REMEDIATION SYSTEM EVALUATION

FORMER OCCIDENTAL FACILITY
TACOMA, WASHINGTON

Report of the Remediation System Evaluation,
Site Visit Conducted at the Former Occidental Facility, Tacoma, Washington
July 8, 2003

EPA 542-F-04-026
August 2004
www.epa.gov/tio
clu-in.org/optimization

FIGURE 1-3. PLANT EAST/WEST GEOLOGIC CROSS-SECTION.

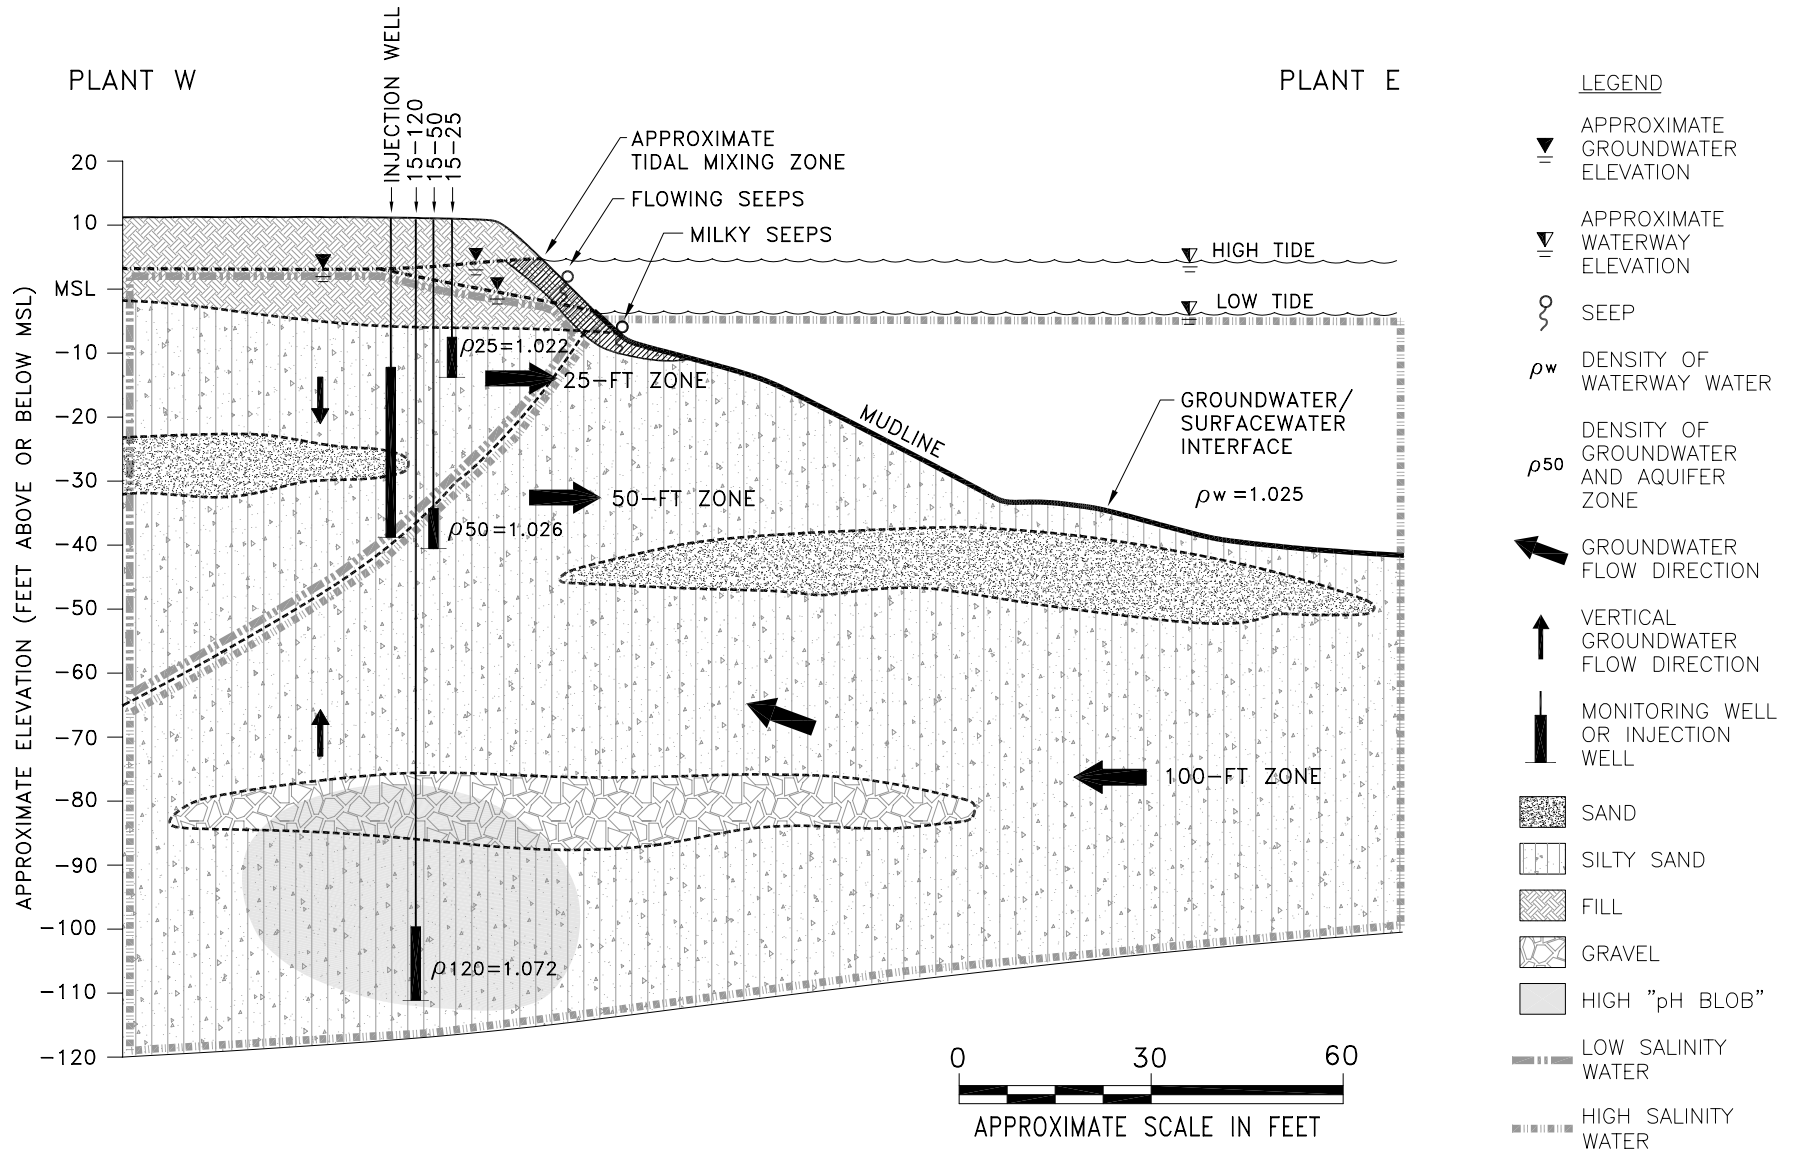
Most of the site monitoring wells are screened in three intervals that are approximately 25, 50, or 100 feet below ground surface within the fluvial deposits. Ground water contamination is generally tracked in each of these intervals but a number of wells are also completed at greater depths. Figures 1-4 through 1-6 show the extent of VOC contamination and the areas with pH over 10 for the 25, 50, and 100-foot depth intervals, respectively. The elevated pH at the 100-foot interval corresponds to the “pH blob” identified in Figure 1-3.

FIGURE 1-6. EXTENT OF CONTAMINATION AT 100 FEET BELOW GROUND SURFACE - AUGUST 2002

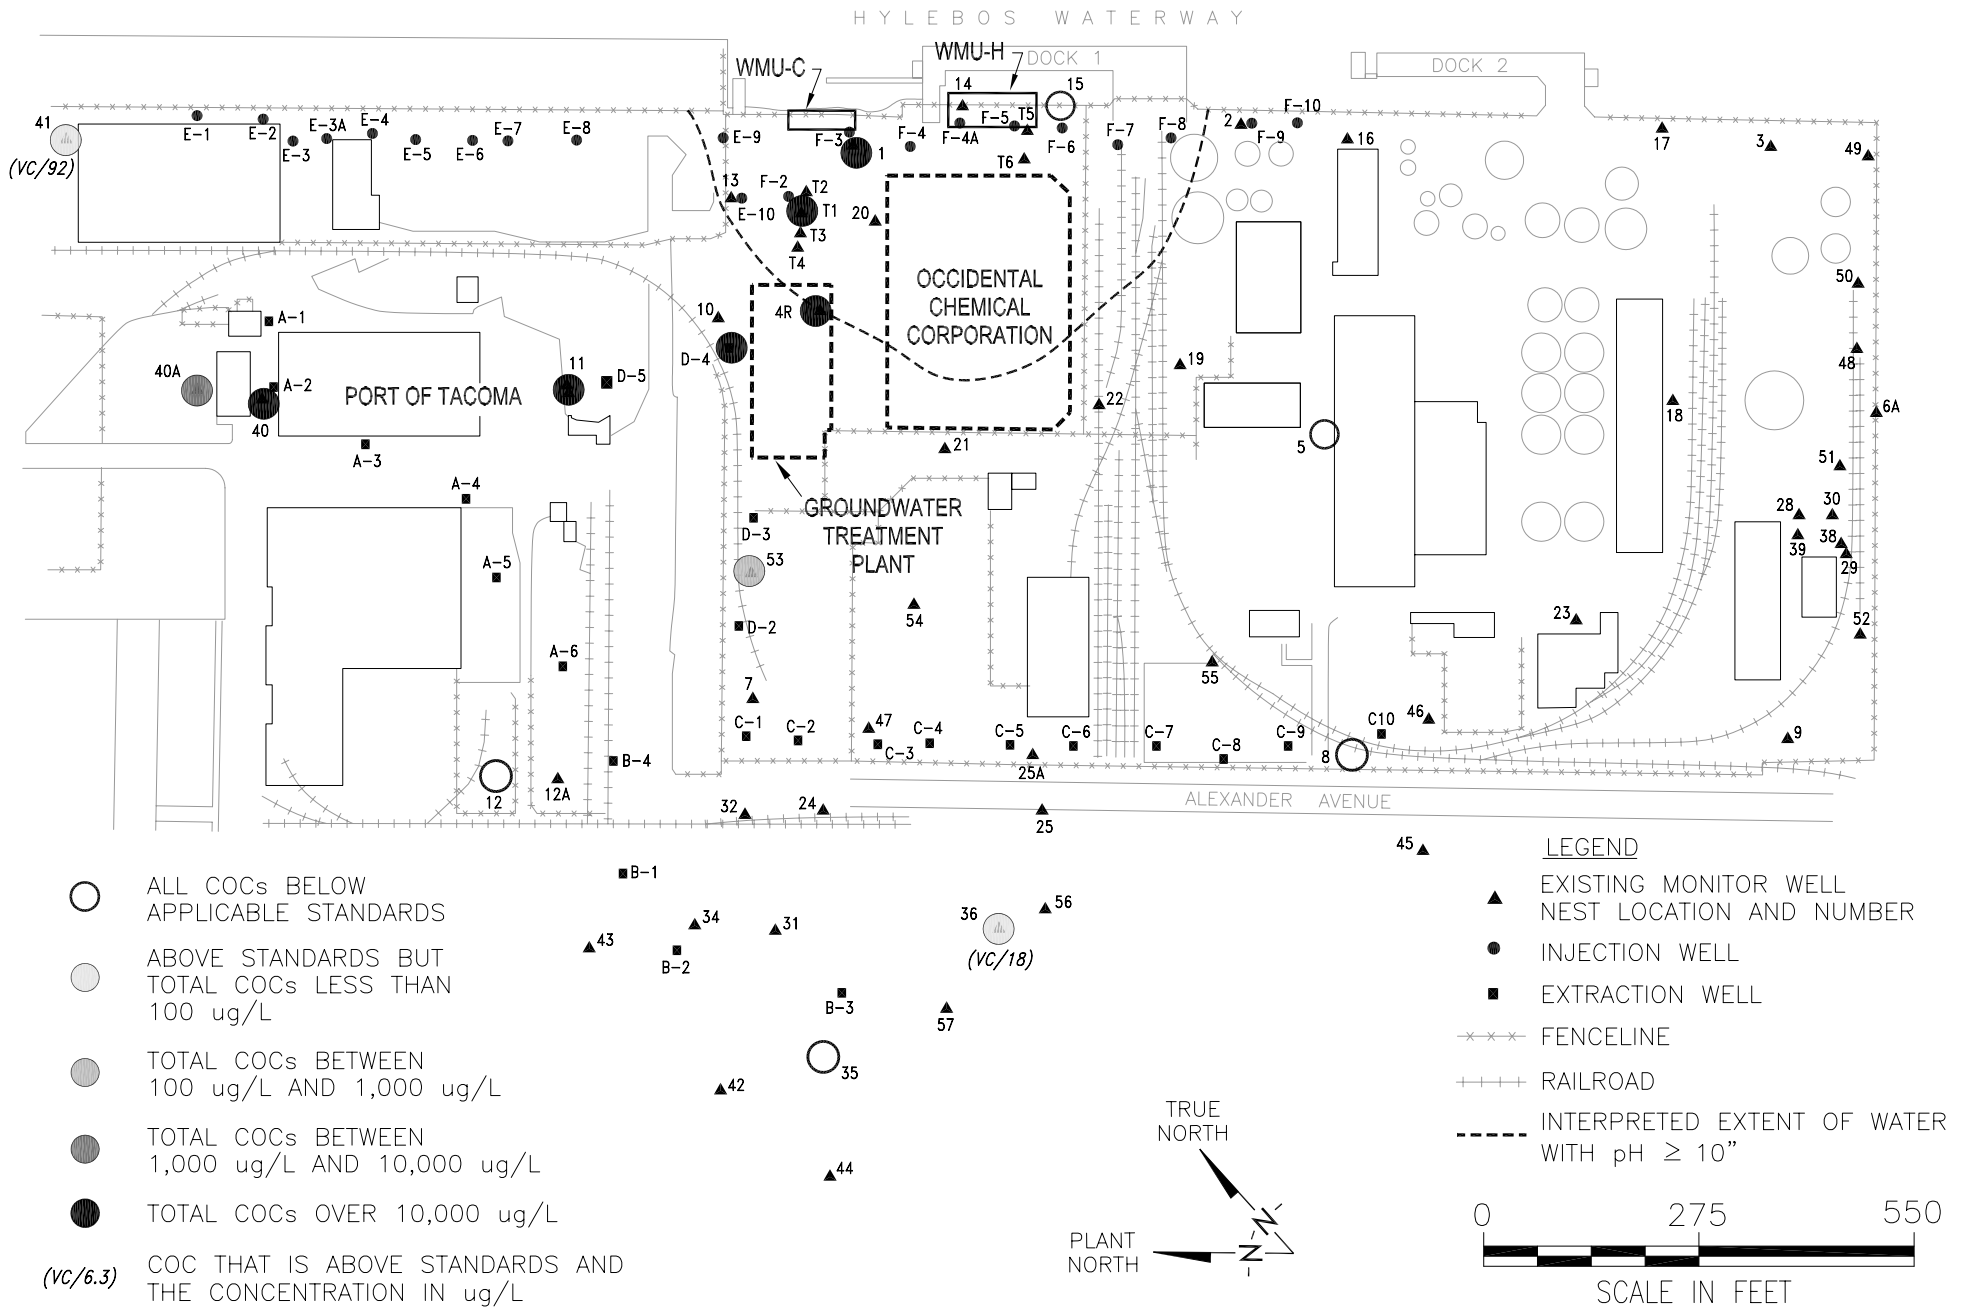
Capture at the 100-foot depth interval is inconclusive due to a lack of data, and a thorough capture evaluation at this depth is also complicated by the lack of plume delineation. In particular, the concentrations at monitoring wells 41-138, 40A-100, and 40-100 all have VOCs well above relevant cleanup standards, and there are no monitoring wells or extraction wells downgradient of these locations to provide delineation. The substantial decrease in VOC concentrations in 41-138 could be interpreted as an indication of capture, but the decrease started well before the addition of A-2A. Therefore, the decrease is likely due to dilution from the injection of clean water at E-1 and the movement of contaminated water further from the site. The increases in VOC concentrations at 40A-100 and 40-100 might indicate that these wells are within the capture zones of nearby extraction wells and that contaminated ground water is passing through these monitoring wells on route to extraction at A-2A. It could also potentially represent uncaptured contamination. Moreover, substantial contamination may exist beyond 40A-100 and 40-100 given that these two wells have substantial concentrations (38,000 ug/L of total contaminants of concern at 40-100 and 9,800 ug/L of total contaminants of concern at 40A-100 in August 2002) and no monitoring points are available to the north.

- Additional monitoring wells are needed to delineate the VOC plume to the north approximately 100 feet below ground surface. The RSE team estimates that approximately four wells to this depth will be needed.

FIGURE 1-7. EXAMPLE POTENTIOMETRIC SURFACE MAP FOR THE 25-FOOT INTERVAL (JANUARY 2002) SUBMITTED AS PART OF AN ANNUAL PERFORMANCE EVALUATION REPORT.

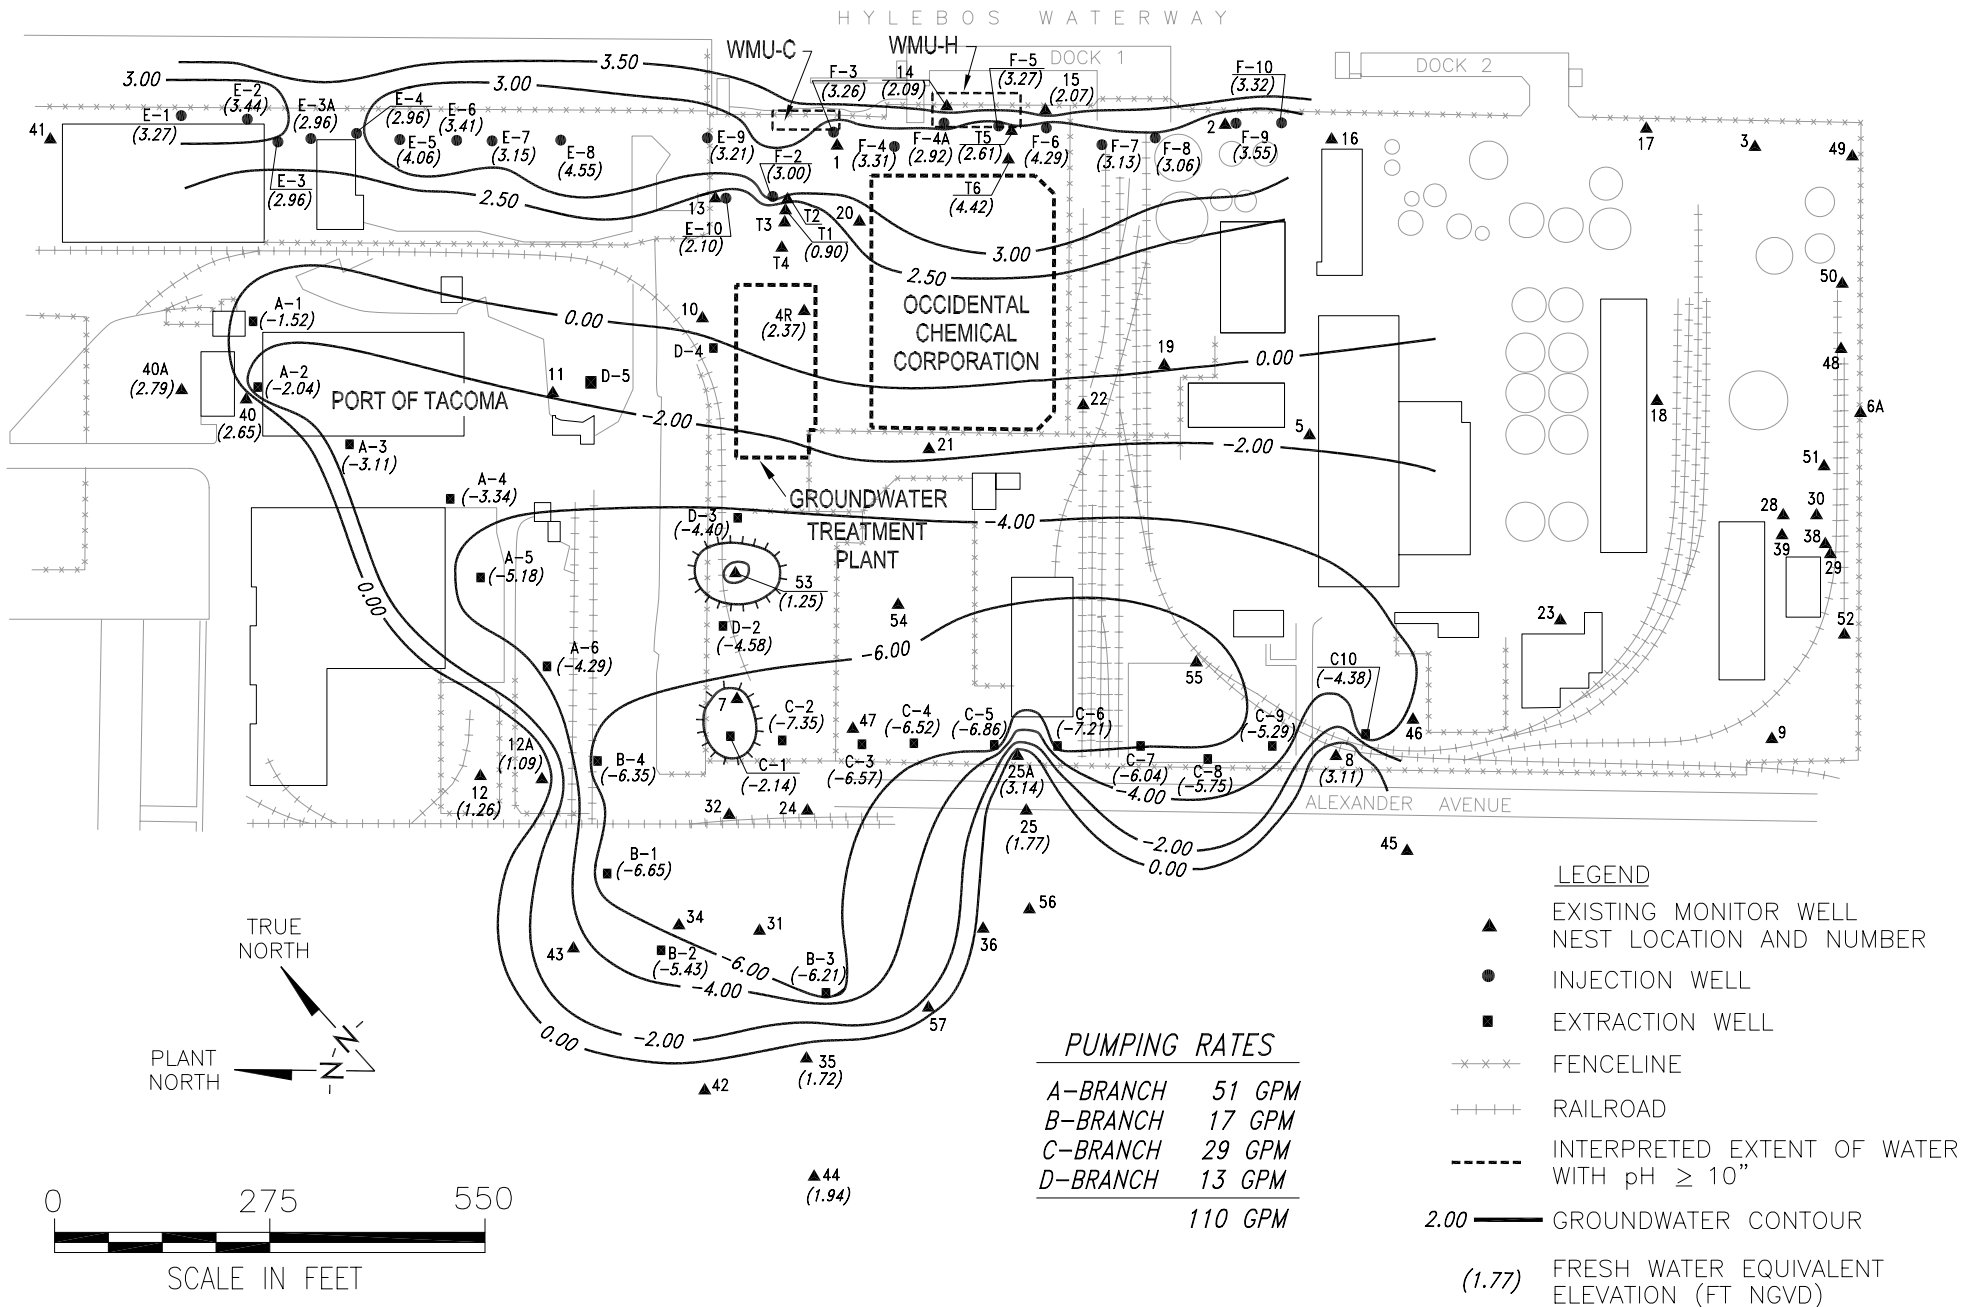
Potentiometric surface maps are generated and reported for each of the three depth intervals (25, 50, and 100 feet bgs) on a quarterly basis. For the 25 and 50-foot intervals, the maps are generated using water levels from monitoring wells and operating injection and extraction wells. However, the water levels from operating injection and extraction wells are not likely indicative of aquifer conditions and using these maps to draw conclusions about plume capture is unreliable. Figure 4-1 provides an example of a potentiometric surface map generated from the January 2002 water level data. The RSE team notes the following inconsistencies from this particular potentiometric surface map and that similar inconsistencies are present in other submitted potentiometric surface maps.

Using data from monitoring wells (and not injection or extraction wells) would provide a different picture of ground water flow across the site. The following examples are provided:

- Evaluation of plume capture and ground water flow should be improved by installing additional monitoring wells to establish well pairs that surround the VOC plume. During each gauging event, the water levels from the two monitoring wells in a well pair should be gauged simultaneously to avoid the need to correct for tidal influence. In addition, the measurements should be made at least four evenly spaced times per day. This will allow the site team to determine the direction of ground water flow at each well pair location at various parts of the tidal cycle. This approach should provide more reliable information regarding capture and should eliminate the need to collect 72-hour continuous water levels at 28 locations, which has required substantial effort and cost and has not added substantially to the understanding of capture at the site.
